CoPTTM Update Note – effective 23 December 2008

New requirements and recommendations for Truck Mounted Attenuator (TMA) appearance, mobile Advance Warning Variable Message Sign (AWVMS) and Light Arrow Systems

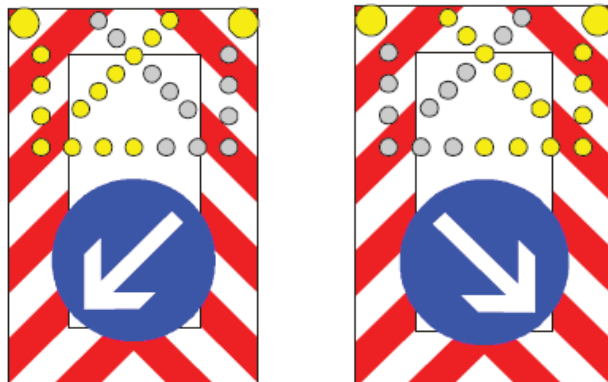
The details of the number and layout of lamps are shown in the diagram.

The minimum number of lamps shall be 24 with a maximum of 25.

The arrow lamps are required to pulse at a rate of 55 to 75 flashes per minute, with the on-period twice the length of the off-period. When the arrow lamps are operating the two synchronised xenon flashing lights shall only flash during the off-period of the arrow lamps.

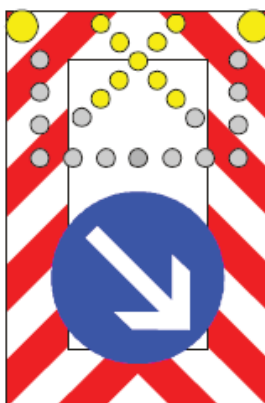
- **Arrow** ~ Lane change required (because a driving lane is closed)

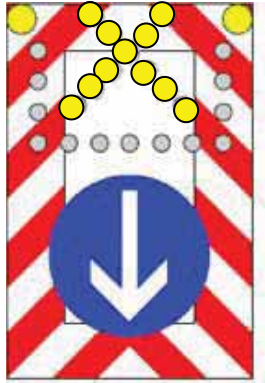
- **Cross** ~ A part of the roadway which is not used for driving is closed (usually a shoulder) – it is safe to pass on the side indicated by the RG17 / 34 sign

Figure C1 TMA for Level 2/3 roads

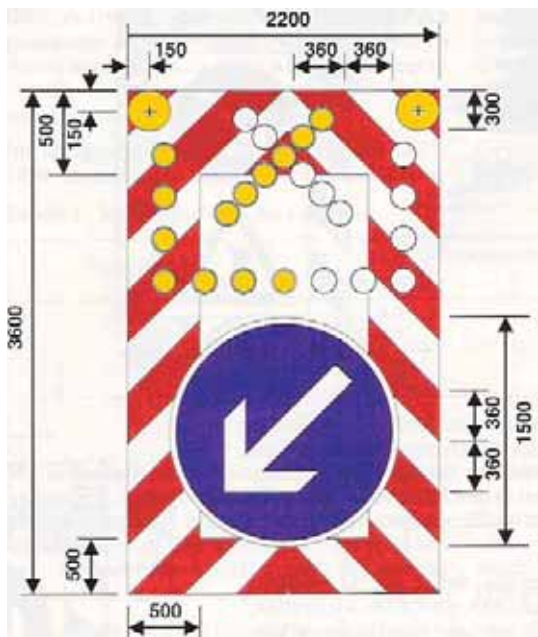
Height: The overall height of the panel shall not exceed 4.25m above the road. The lower 500mm panel may need to be installed on the rear of the TMA to remain under the maximum height specified in law.

Enlarged RG17: 1500mm diameter (+or - 50mm). The sign shall be illuminated by the installation of white lighting with a minimum output of 50 watt.

Xenon Lights: Are to be installed in the top left and right hand corner of the panel as per the drawing.

Equipment Control: The rear panel shall have a device installed to ensure that the arrowboard and the RG17 are always aligned. A display must be visible to the operator to confirm orientation.

Deck Mounted Uplighting: An upright is to be attached to the deck to adequately illuminate the RG 17/34.

Organisations' signage or logos: must not be installed on the rear panel.

Maximum height to top of display from ground level must not exceed 4.25m

**Section C4
Level 1 Roads**

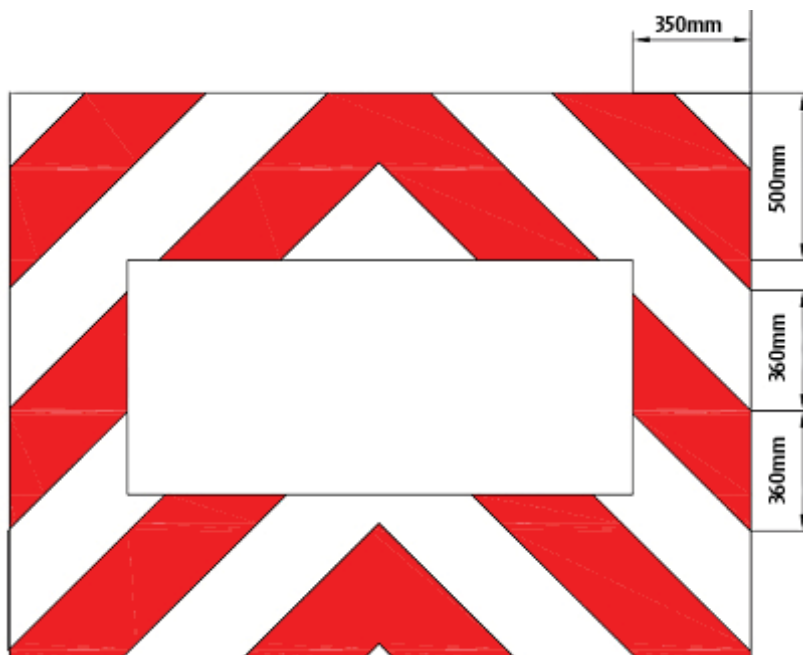
NZTA's long term vision is to create consistency within the New Zealand Network and would encourage the retrofitting of existing rear panels to match the same red/white pattern as used in the new panel display.
